Item Name: Crosstube Turning Detail

<b>DART AEROSPACE LTD</b>		<b>Work Order:</b>	12 0862
<b>Description:</b> Crosstube Assembly		<b>Part Number:</b>	D206-667-241
<b>Inspection Dwg:</b> D206-667-241 Rev: C		<b>Page 1 of 2</b>

DESIGN	9	<b>DART AEROSPACE LTD</b>	
DRAWN	RF	HAWKESBURY, ONTARIO, CANADA	
CHECKED	17	DRAWING NO.	REV. C
MFG. APPR.	17	D206-667-241	SHEET 4 OF 4
APPROVED	17	TITLE	SCALE
DE APPR.	17	CROSSTUBE ASSY (206B HIGH AFT)	NTS
DATE	08.11.06	<small>COPYRIGHT © 2000 BY DART AEROSPACE LTD THIS DOCUMENT IS PRIVATE AND CONFIDENTIAL AND IS SUPPLIED ON THE EXPRESS CONDITION THAT IT IS NOT TO BE USED FOR ANY PURPOSE OR COMMUNICATED TO ANY OTHER PERSON WITHOUT WRITTEN PERMISSION FROM DART AEROSPACE LTD.</small>

DRAWING NO. D206-667-241	TITLE CROSSTUBE ASS'Y (206B HIGH AFT)	REV. C	<b>DART AEROSPACE LTD ENGINEERING ORDER</b>	D.E.O. NO. D206-667-241-C-1	SHEET NO. SHEET 1 OF 1	SCALE NTS
DRAWN <i>qp</i>	CHECKED <i>AS</i>	MFG. APPR. <i>M</i>	APPROVED <i>WD</i>	DE APPR. <i>HA</i>		
DATE 11.07.15	DATE 11.08.22	DATE 11.08.22	DATE 11/08/22	DATE 11.08.22

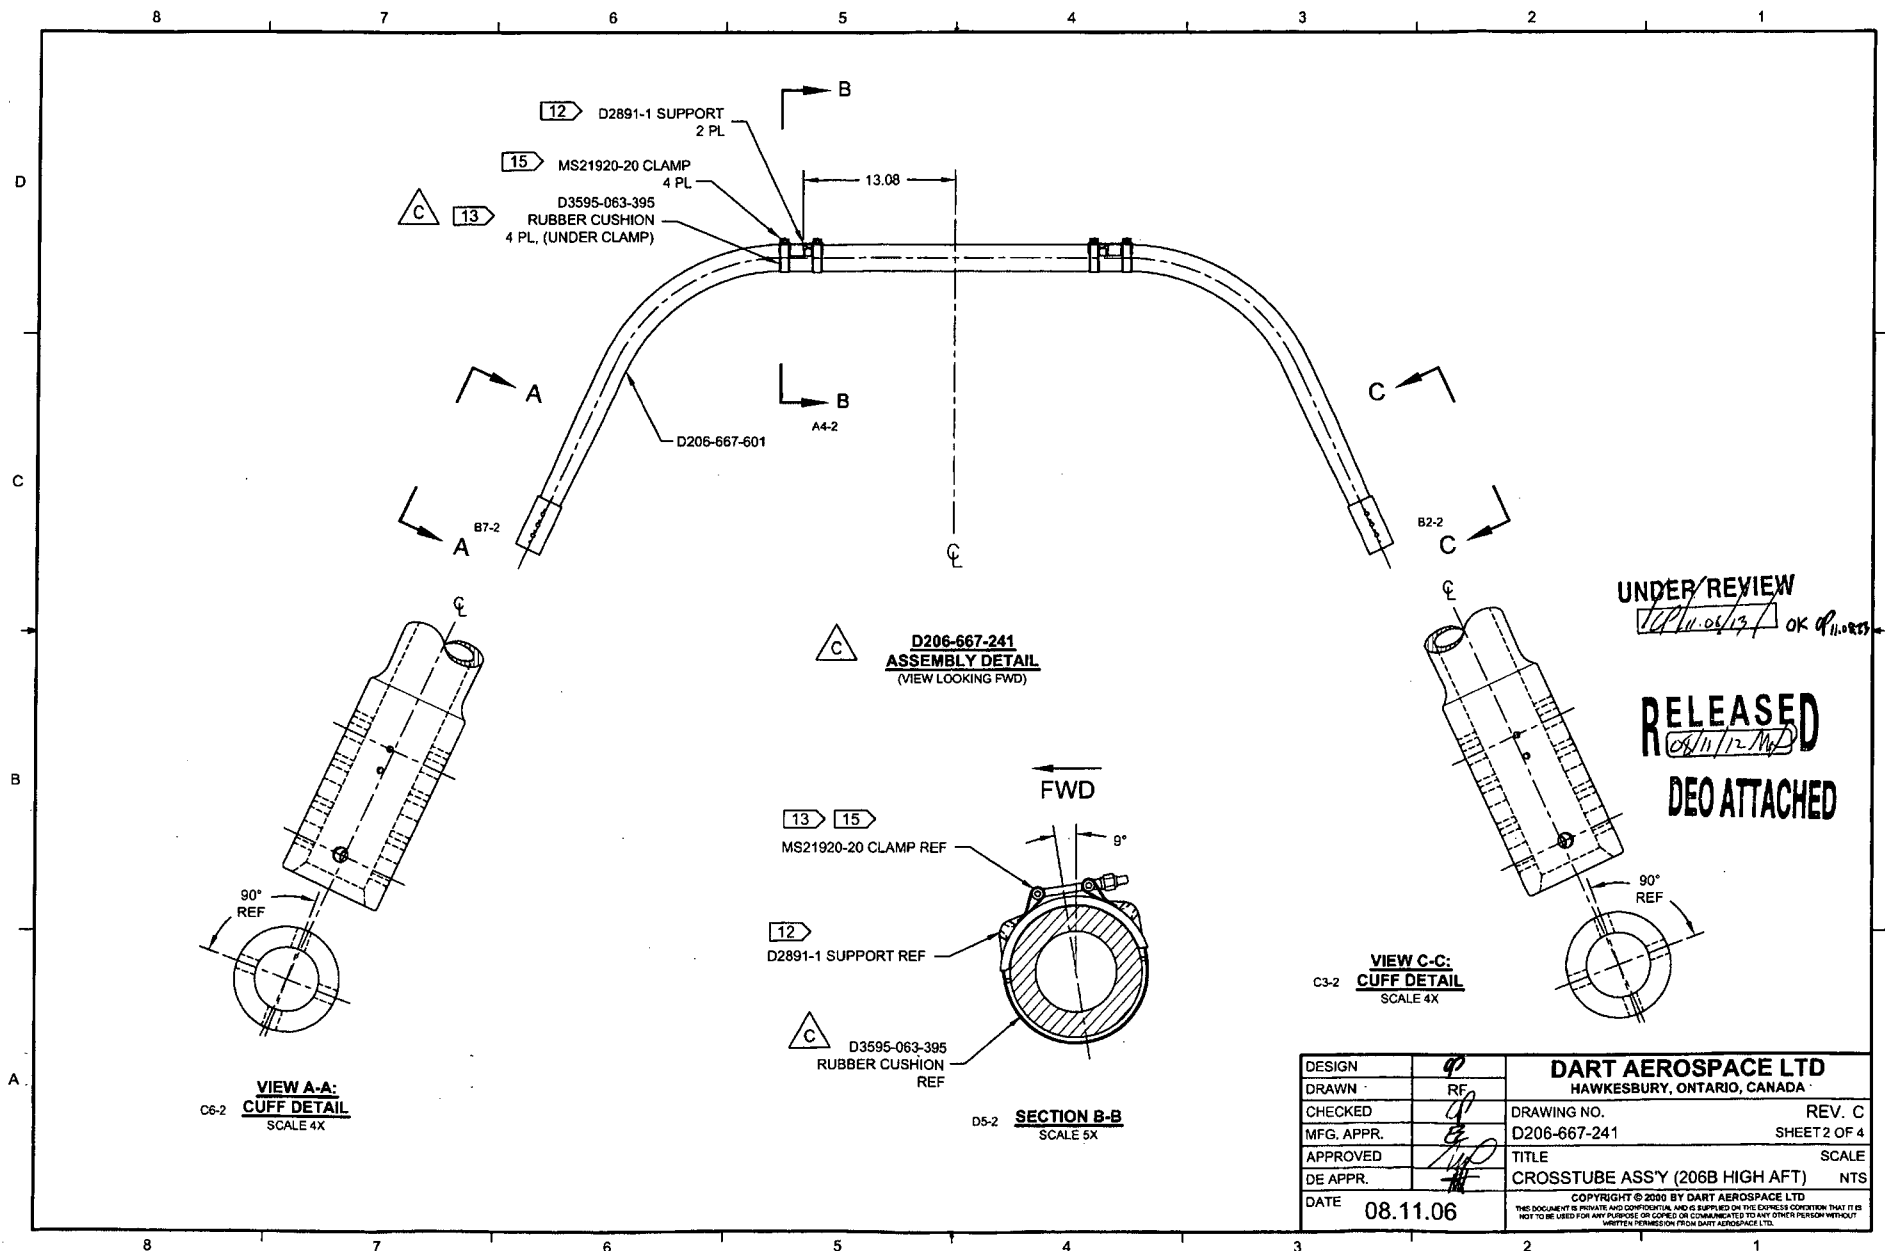
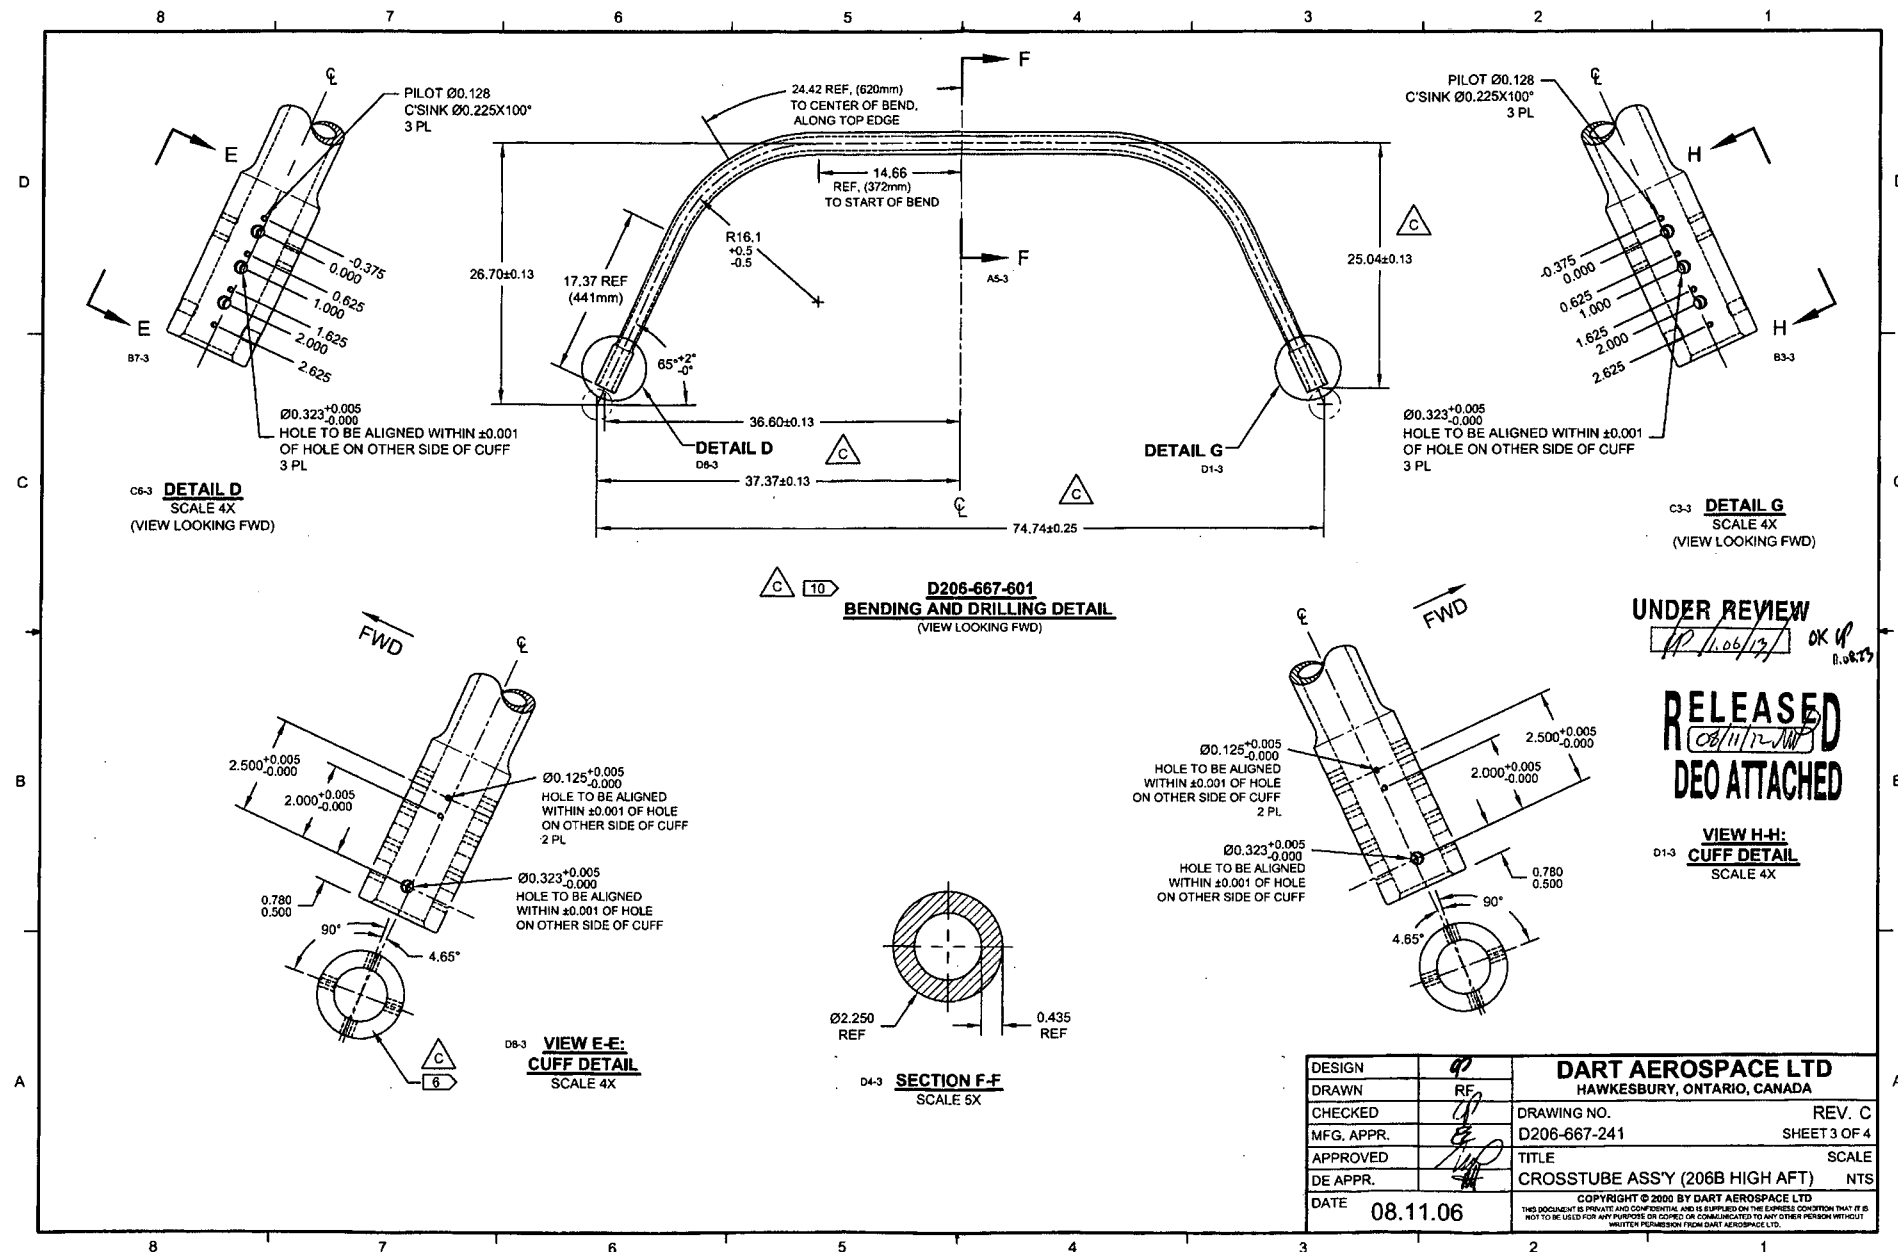
C	REFORMAT/REVISE GENERAL NOTES/PART LIST (ZN D7-1); REORGANIZED VIEWS AND REFORMATTED DRAWING TO CURRENT STANDARDS. D3595-063-395 WAS D2856-400-694 (ZN D8-2 & A5-2); REMOVED REF. & ADD TOLERANCES (ZN C5-3, C4-3, D3-3); RELOCATED FLAG #6 (ZN A7-3) PER NCR 210; MOVED TURNING DETAIL & UPDATED TOLERANCE TO SHEET 4.	RF	08.11.06
B	ADD HOLES FOR COMPATABILITY WITH BHT/AA SKIDTUBES	PH	05.02.04
A	NEW ISSUE	CP	00.11.17
REV.	DESCRIPTION	BY	DATE
DESIGN	RF	DART AEROSPACE LTD HAWKESBURY, ONTARIO, CANADA	
DRAWN	RF	DRAWING NO.	REV. C
CHECKED	RF	D206-667-241	SHEET 1 OF 4
MFG. APPR.	RF	TITLE	SCALE
APPROVED	RF	CROSSTUBE ASSY (206B HIGH AFT)	NTS
DE APPR.	RF	COPYRIGHT © 2000 BY DART AEROSPACE LTD THIS DOCUMENT IS PRIVATE AND CONFIDENTIAL AND IS SUPPLIED ON THE EXPRESS CONDITION THAT IT IS NOT TO BE USED FOR ANY PURPOSE OR COPIED OR COMMUNICATED TO ANY OTHER PERSON WITHOUT WRITTEN PERMISSION FROM DART AEROSPACE LTD.	
DATE	08.11.06

**TURNING DETAIL**

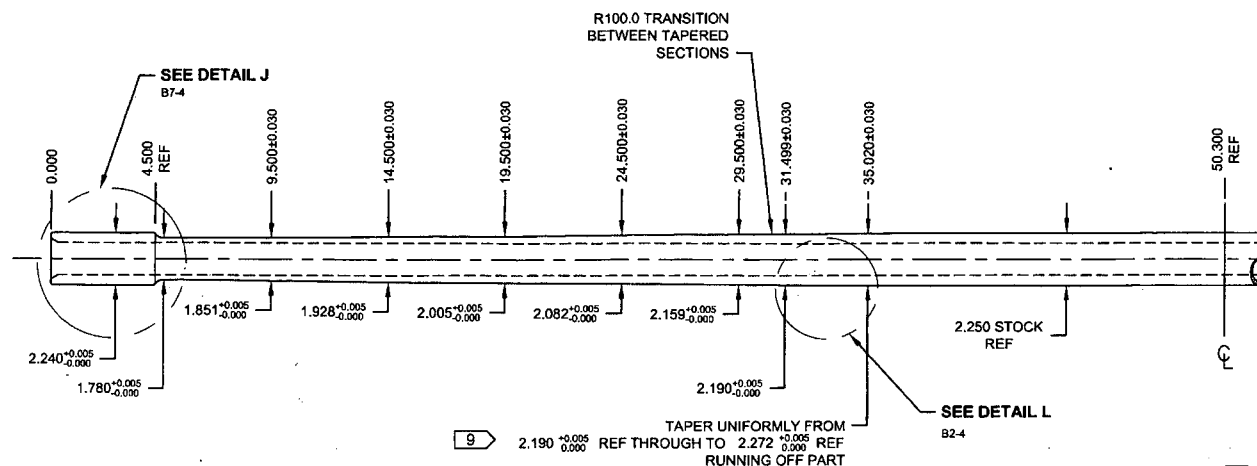
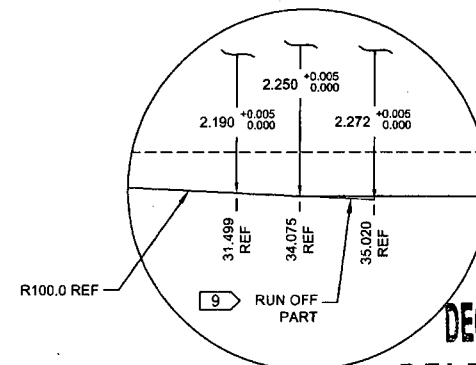
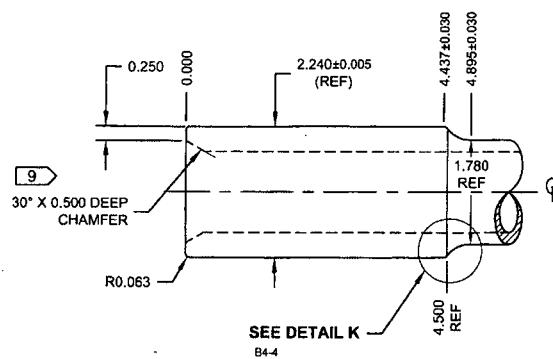
**DETAIL K: CUFF TRANSITION**  
A6-4  
NOT TO SCALE

**DETAIL L: TAPER RUN-OFF**  
C4-4  
NOT TO SCALE

**DETAIL J: CROSSTUBE CUFF**  
D7-4  
NOT TO SCALE
